Subject: Exelon Nuclear Texas Holdings, LLC
Victoria County Station Early Site Permit Application
Response to Request for Additional Information Letter No. 06
NRC Docket No. 52-042

Attached are responses to NRC staff questions included in Request for Additional Information (RAI) Letter No. 06, dated March 31, 2011, related to Early Site Permit Application (ESPA), Part 2, Sections 02.04.04 and 13.03. NRC RAI Letter No. 06 contained twenty (20) RAIs. This submittal comprises a partial response to RAI Letter No. 06, and includes responses to the following seventeen (17) Questions:

RAI 02.04.04-2:**Question:**

RAI 13.03-20:**Question:**

Figure 1. Time History of Water Level at the Southwestern Corner of the Security Wall for Manning's n Sensitivity Test (The water level for $n=0.03$ is the same as SSAR Figure 2.4.4-21, and the starting time is arbitrarily selected.)

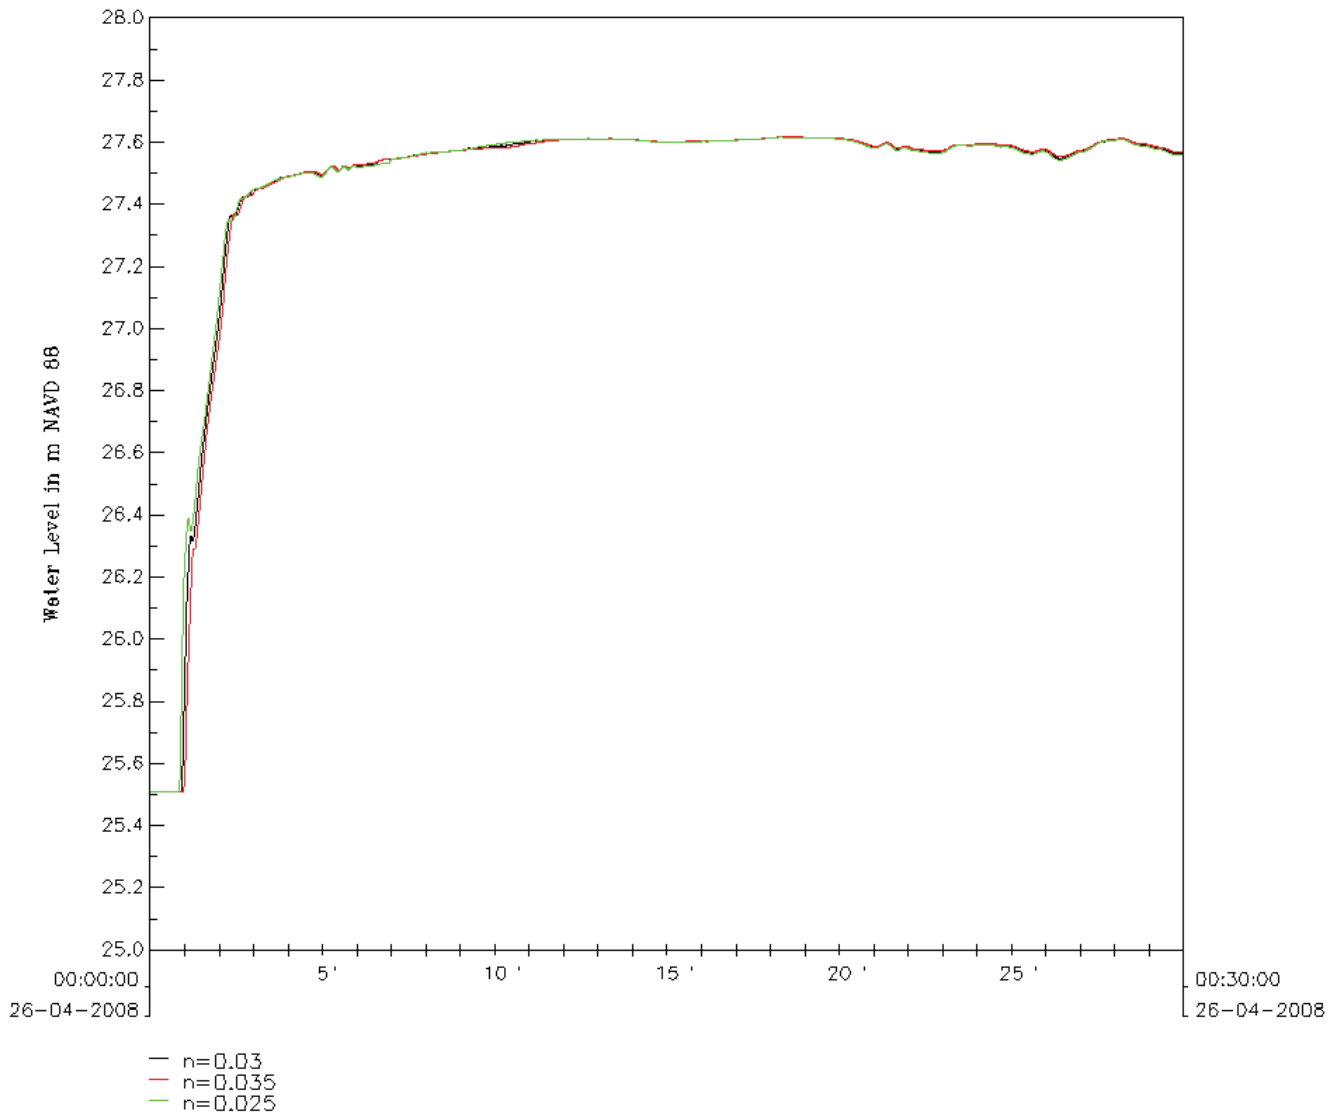
The staff has reviewed the application in accordance with the requirements of “Factors to be considered when evaluating sites” 10 CFR 100.20(c), and “Contents of application: technical information in the final safety analysis report” 10 CFR 52.79(a). The application does not provide detailed information discussing the cooling basin pool elevation selected for analysis and does not provide the background on the selection of the Manning’s n . Please provide additional information showing the selection of the cooling basin initial water surface elevation and the selection of Manning’s n in the vicinity of the breach, where applicable, considering that there are more conservative assumptions available.

In response to this RAI, the first paragraph of SSAR Subsection 2.4.4.2.2.5 (page 2.4.4-11), Revision 0 will be revised as follows:

In response to this RAI, the first paragraph of SSAR Subsection 2.4.4.2.2.4 (page 2.4.4-11), Revision 0 will be revised as follows:

Figure A-1

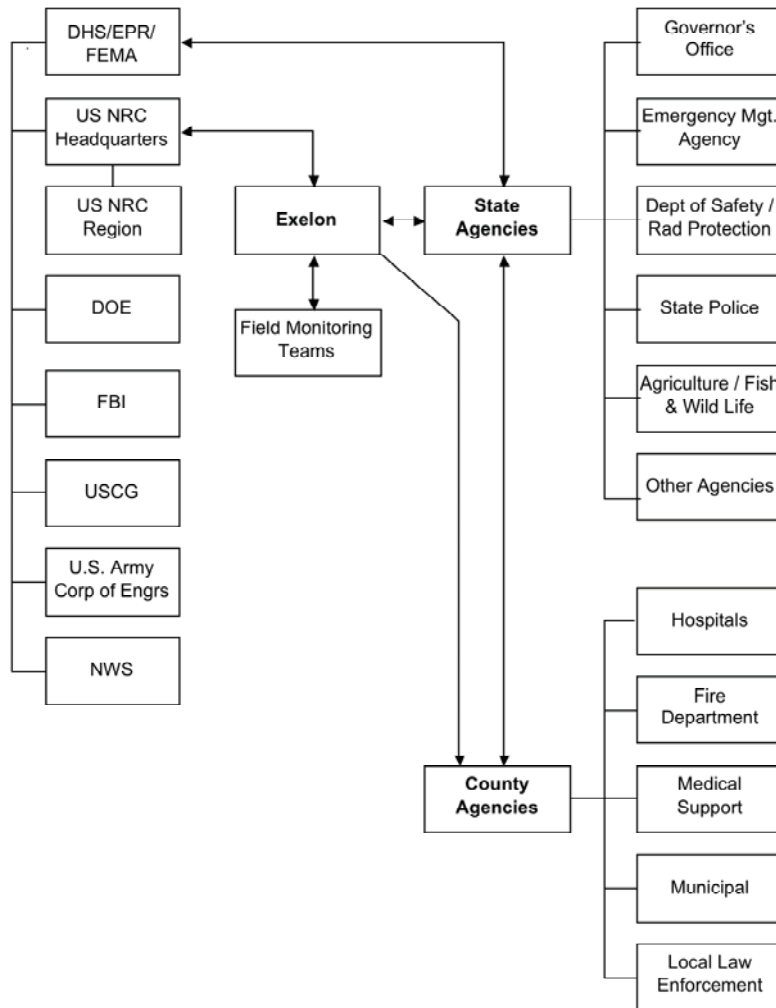
- RAI A-7. Include the Department of Homeland Security (DHS) in Figure A-2 of the Exelon Nuclear Standardized Radiological Emergency Plan, "Agency Response Organization Interrelationships" or justify why this is not necessary.
- RAI A-8. Section A.3 of the Exelon Nuclear Standardized Radiological Emergency Plan, "Agreements in Planning Effort," explains that written agreements have been developed that establish the concept of operations between the applicant and other support organizations having an emergency response role. Provide copies of the Letters of Agreement established with local support agencies in the Emergency Plan or Annex, or describe where these documents are maintained.

RAI A-7 Figure A-1 in the VCS Annex has been revised to replace FEMA with DHS/EPR/FEMA.

Figure 4-1: Victoria County Station PAR Determination Flowchart

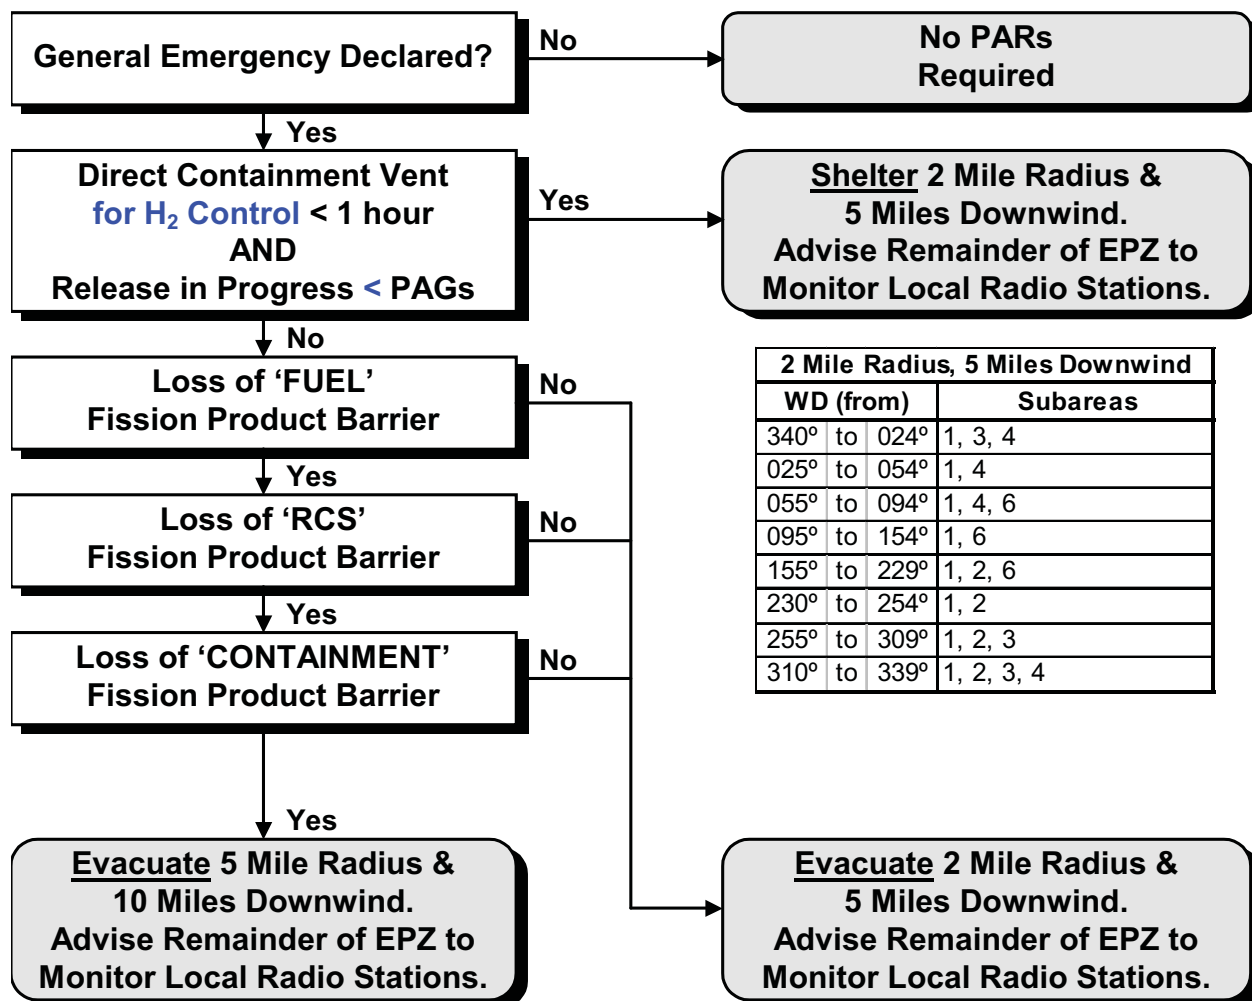
- RAI J-5. Figure 4-1, "Victoria County Station PAR Determination Flowchart," of the Victoria Annex provides the steps considered in making the PAR determination. Explain in the Annex how the Evacuation Time Estimate is used in conjunction with PARS to develop the evacuation plan or justify why this is not necessary.

RAI J-5: NUREG-0654, Supplement 3 provides guidance on the issuing of Protective Action Recommendations (PARs) for the general public. Unless determined by Exelon during a declared General Emergency that the release of radioactive material is a "puff release" the ETE will not be considered when making protective action recommendations. The Plant operators may not have information regarding the environmental concerns regarding the off-site areas surrounding the site. The county or state officials will take into consideration the ETE for the current environmental conditions and make a decision to utilize the VCS PARs or to modify them based on additional information that they have concerning the evacuation routes.
